JONES
ASSOCIATES
Foresters, Surveyors and
Environmental Consultants

March 7th, 2023

On behalf of Auburn Suburban Baseball and Softball, Jones Associates, Inc. is pleased to submit information regarding their Development Review Application for their proposed project located at Stevens Mill and Hotel Road in Auburn, Maine. This information is being submitted by request of the Planning, Permitting, and Code Department, as outlined in an email sent on February 21st, 2023, and during a remote meeting held on February 27th, 2023.

PROJECT NAME: SITE PLAN
AUBURN SUBURBAN
BASEBALL & SOFTBALL
STEVENS MILL ROAD
AUBURN, MAINE

EXISTING WATERSHED PLAN

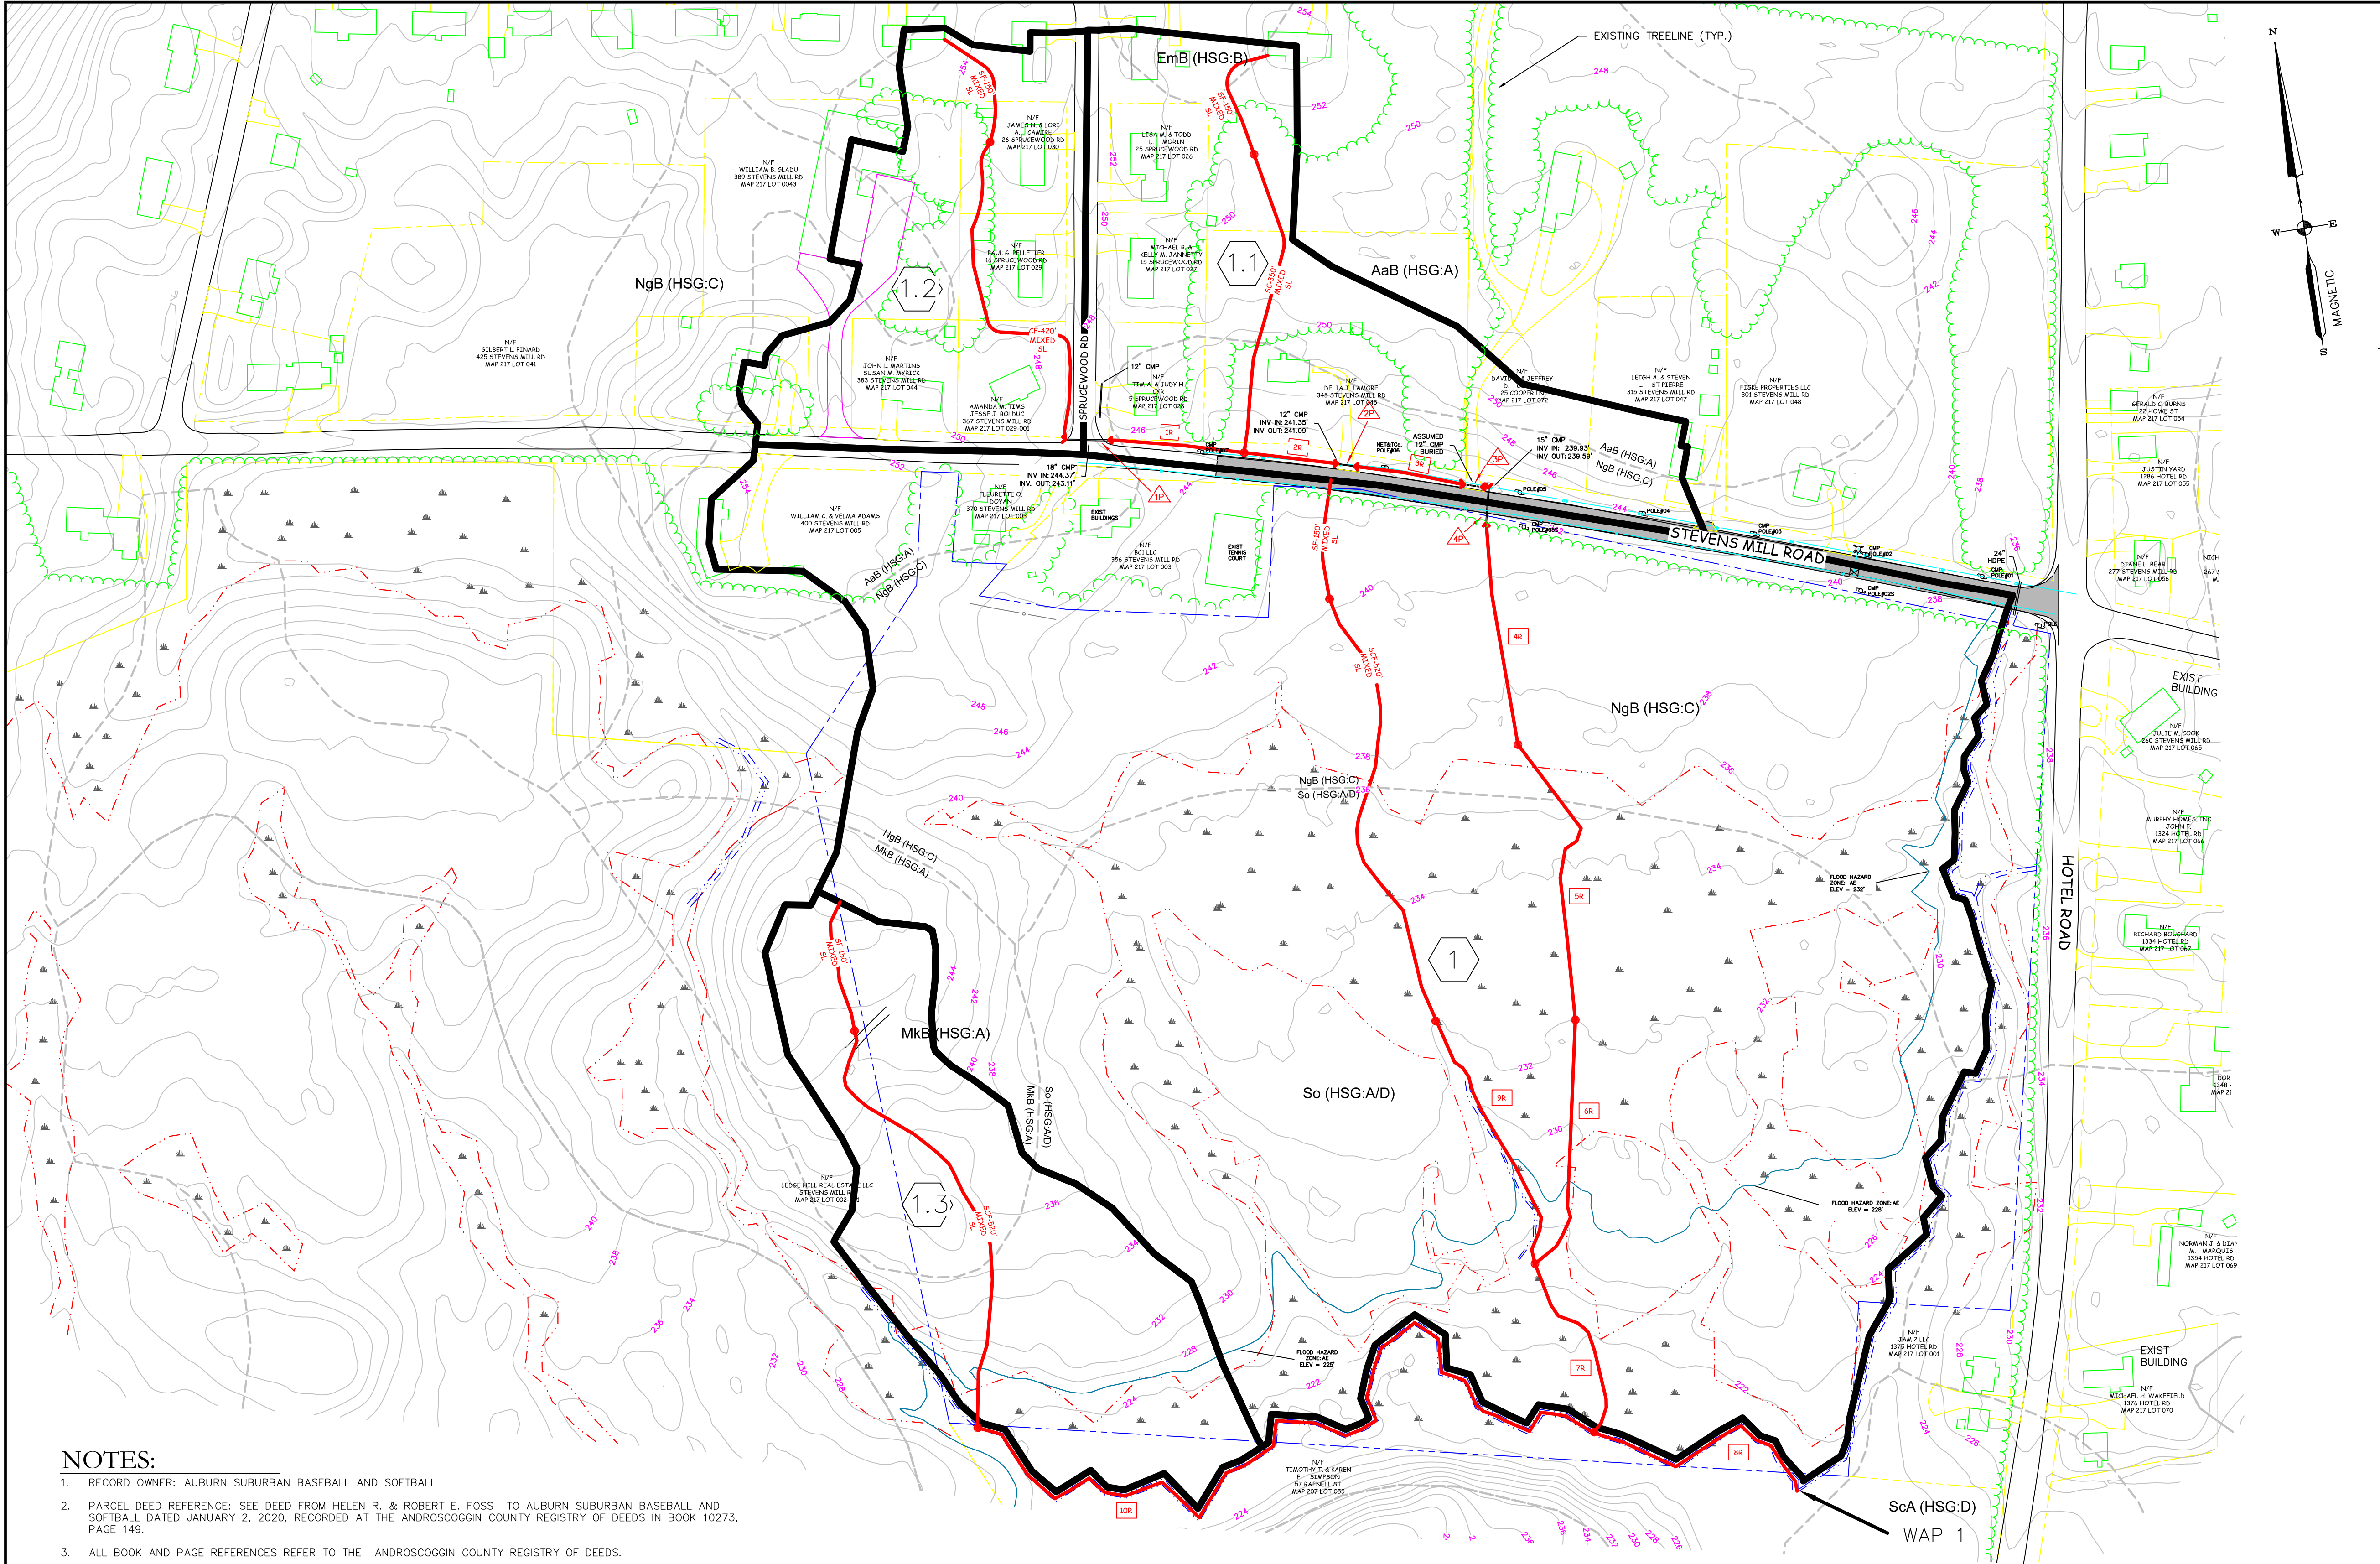
REVISIONS			
NO.	DATE	DESCRIPTION	BY
1	2-22-23	ADJUSTMENT OF SUB. 1, 1.1, AND 1.2 FLOWPATHS	BAS

PROPOSED WATERSHED PLAN

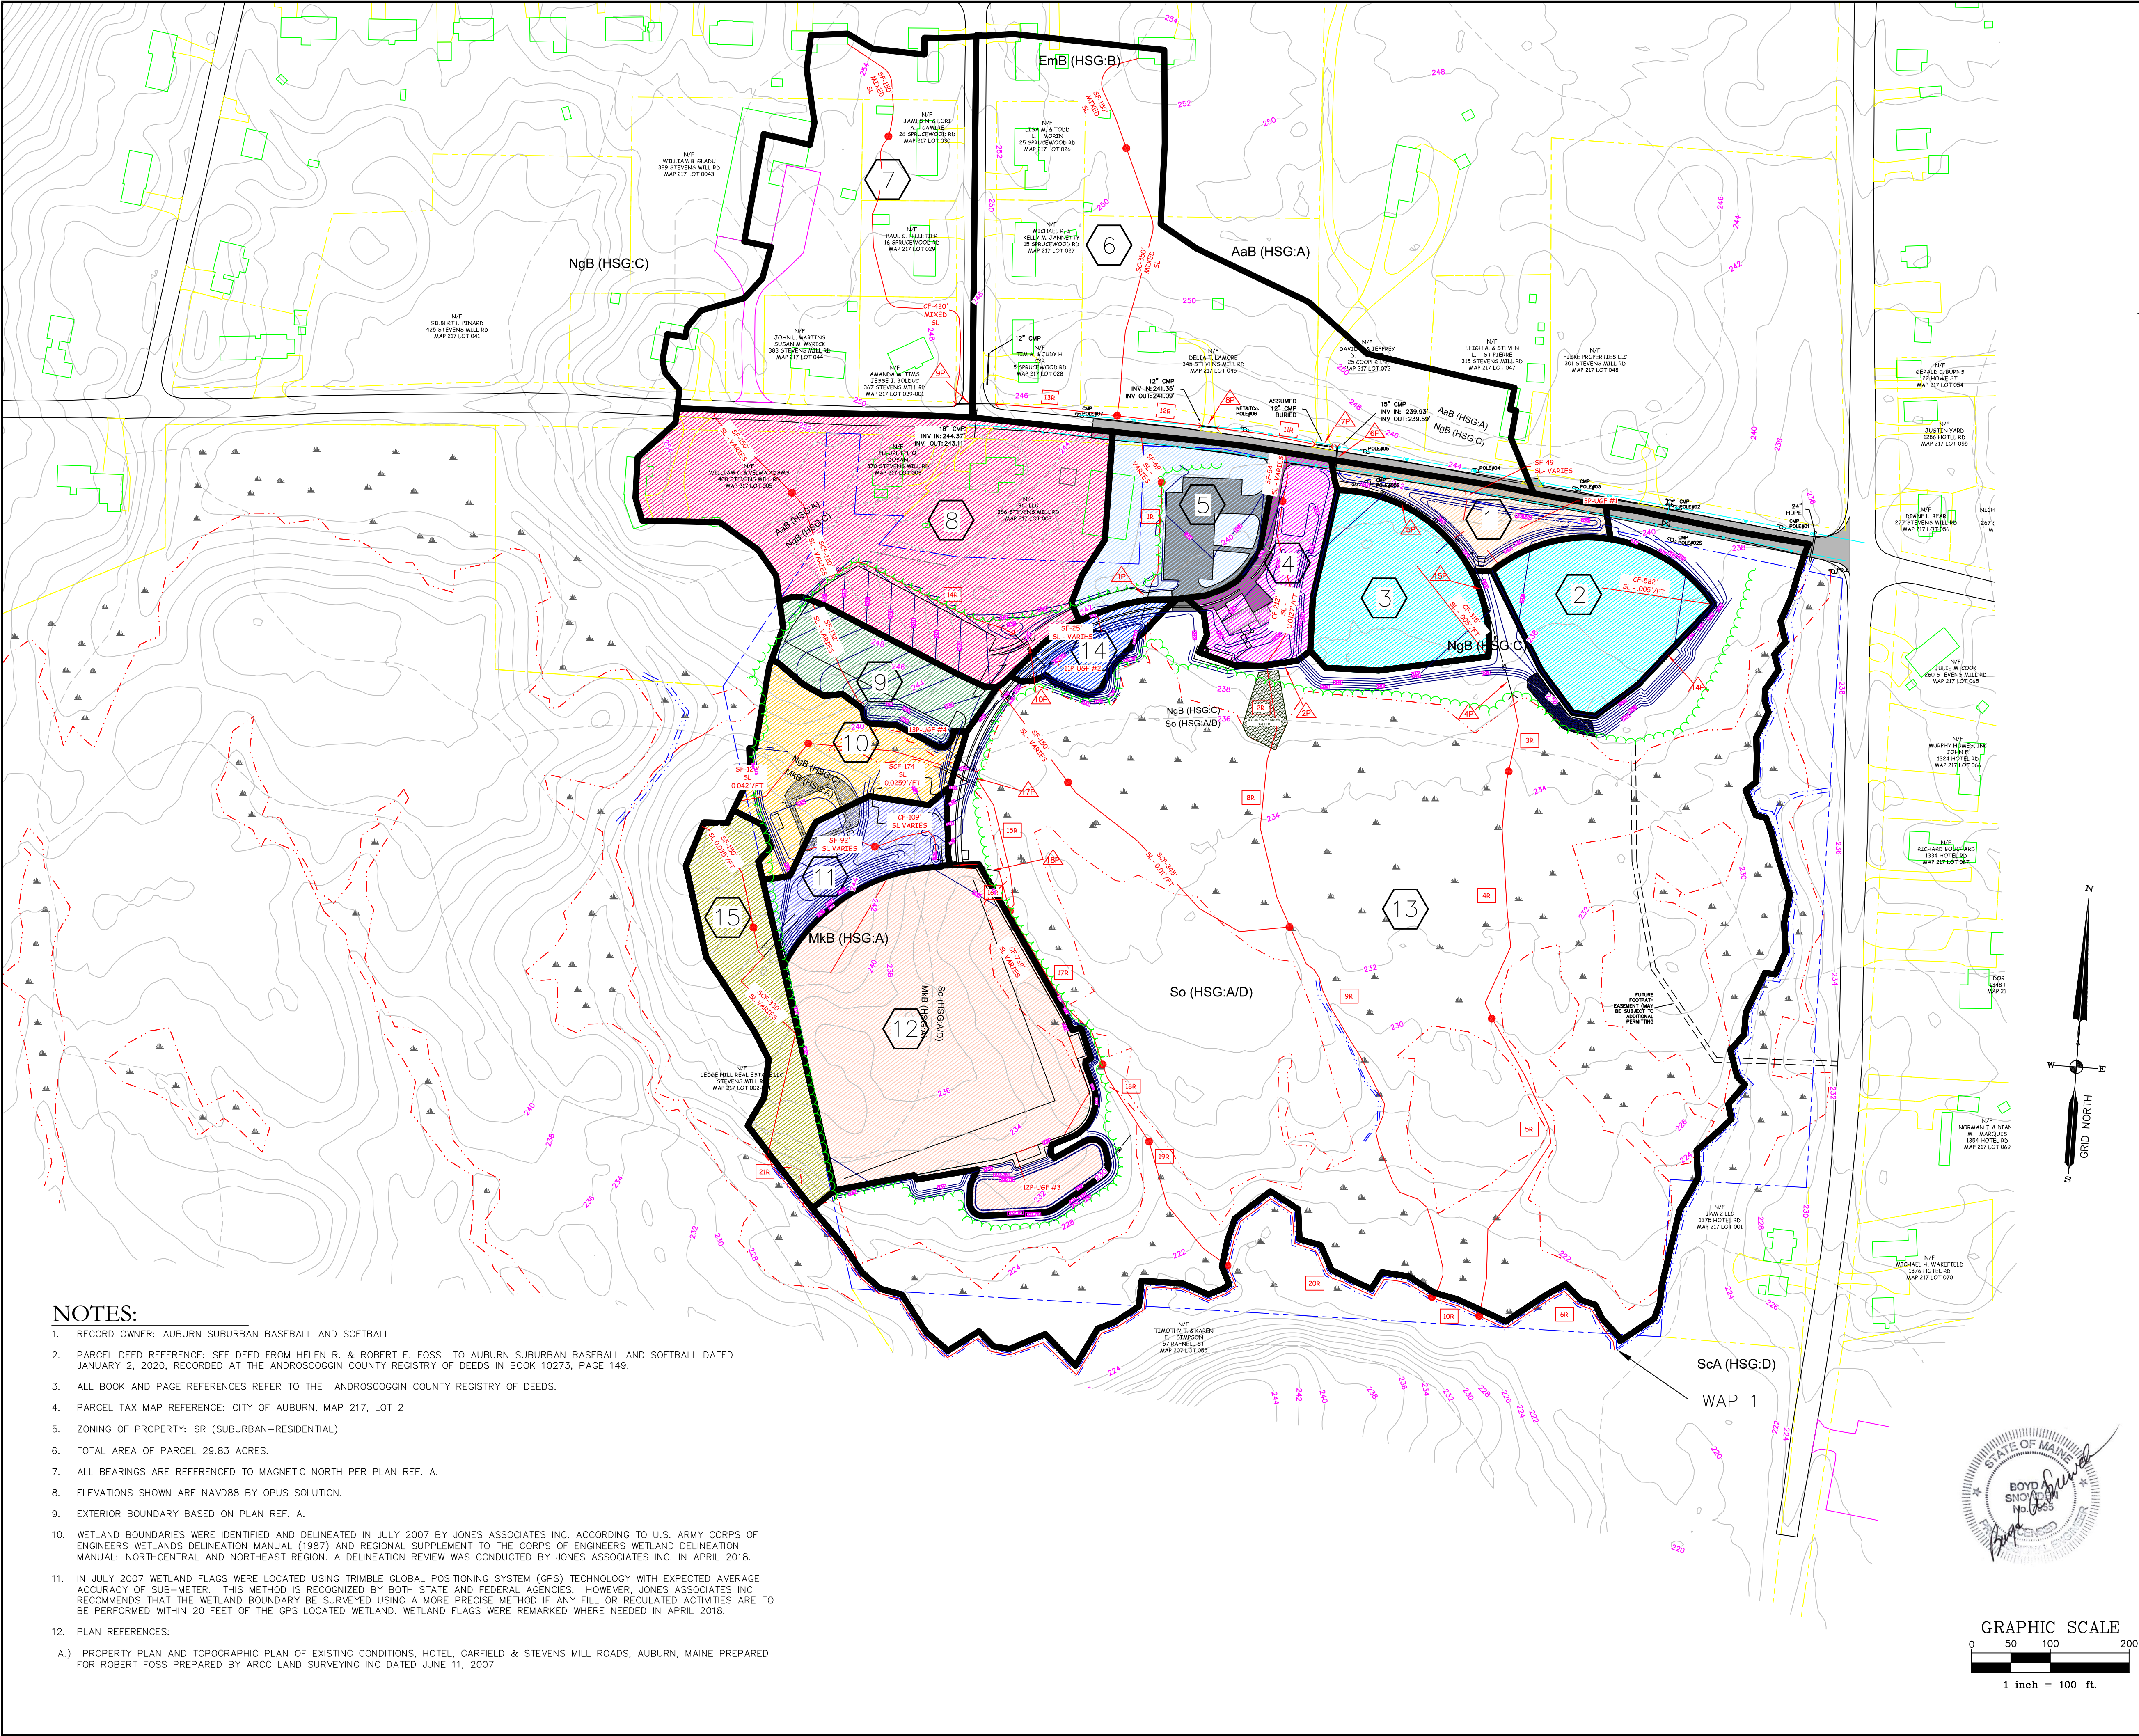
REVISIONS		
NO.	DATE	DESCRIPTION
1	2-28-23	ADJUSTMENT OF SUBCATCHMENTS, FLOWPATHS, ETC. BAS
